Proposed Revisions to a Standard Plans Index

Contact Information:	Standard Plans:
Date: July 26, 2020	Index Number: 536-002
Originator: Richard Stepp	Sheet Number (s): 3
Phone: (850) 414-4313	Index Title: Guardrail Transitions and Connections for
Email: richard.stepp@dot.state.fl.us	Existing Bridges

CHEFT
AND	INDEX	SHEET
BRIDGES	536-002	3 of 28

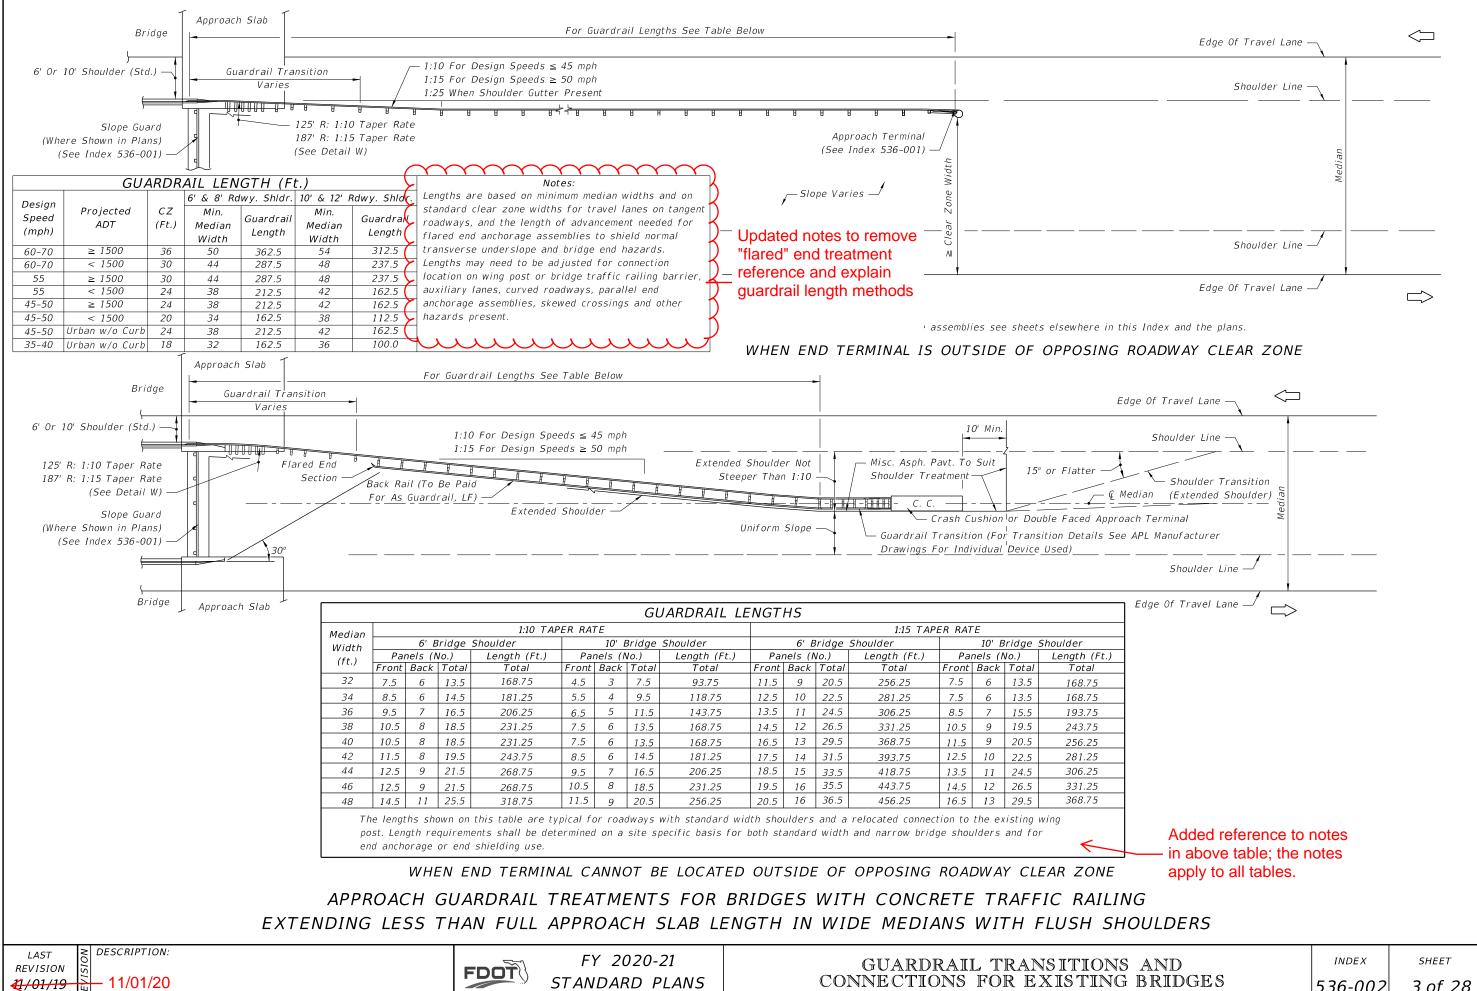
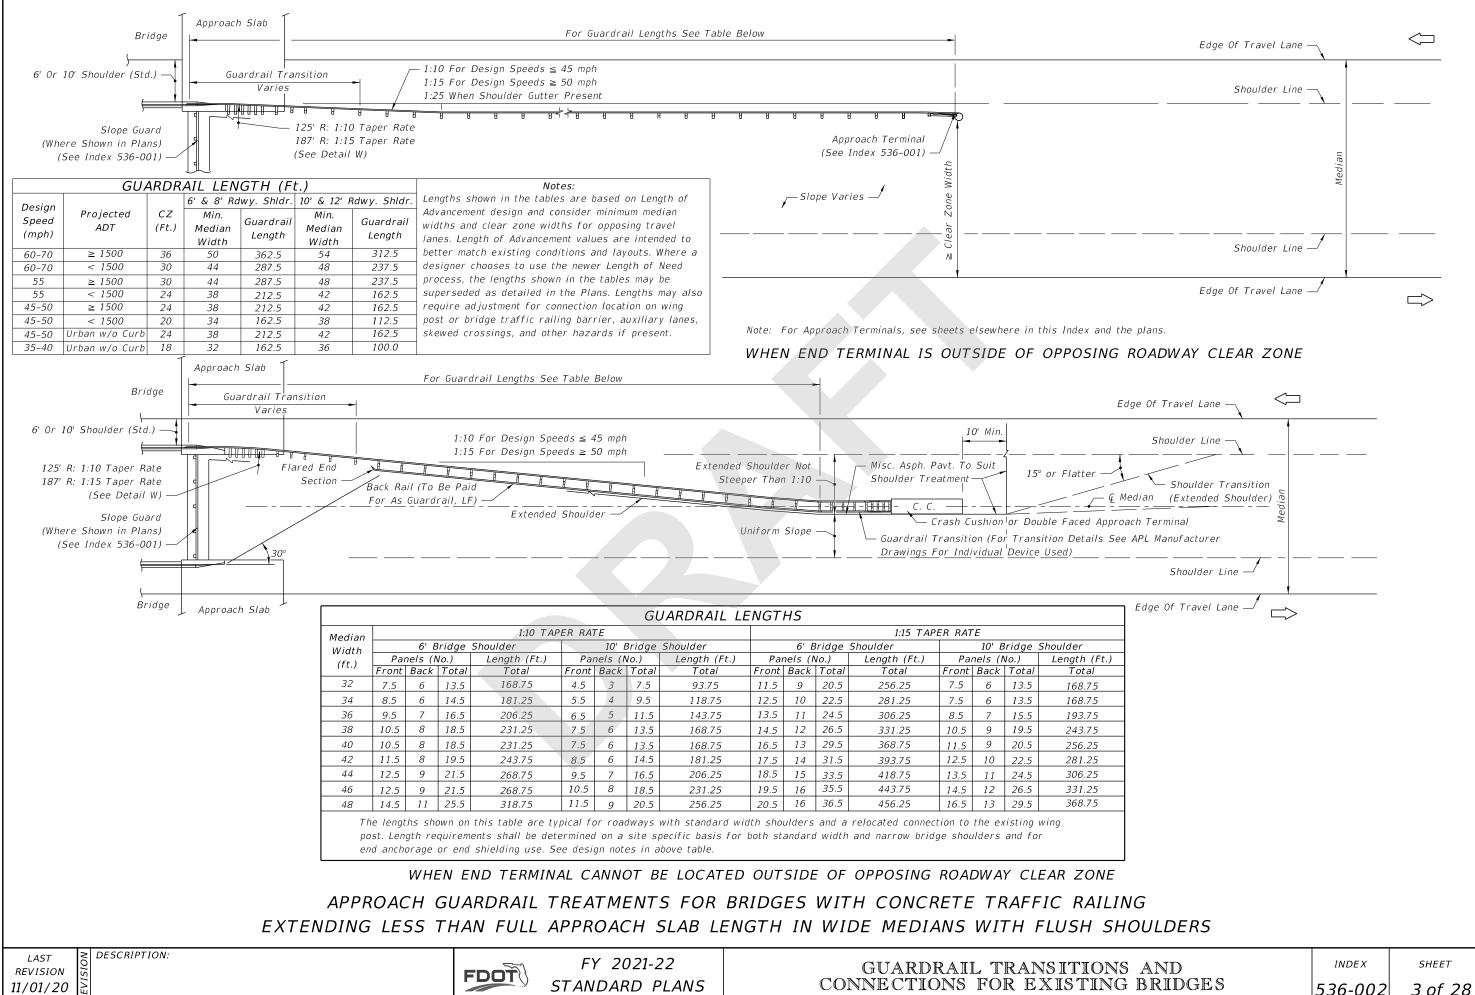
Sheet 3: Remove "Flared" end treatment verbiage in note for table of guardrail lengths. Updated table notes to explain usage of 'Length of Advancement' method for tables while explaining optional usage of 'Length of Need' calculations by designer.

Flared Terminals (or "Flared Anchorages") are no longer used due to MASH requirements. Additional explanation was added to clarify guardrail length calculation options.
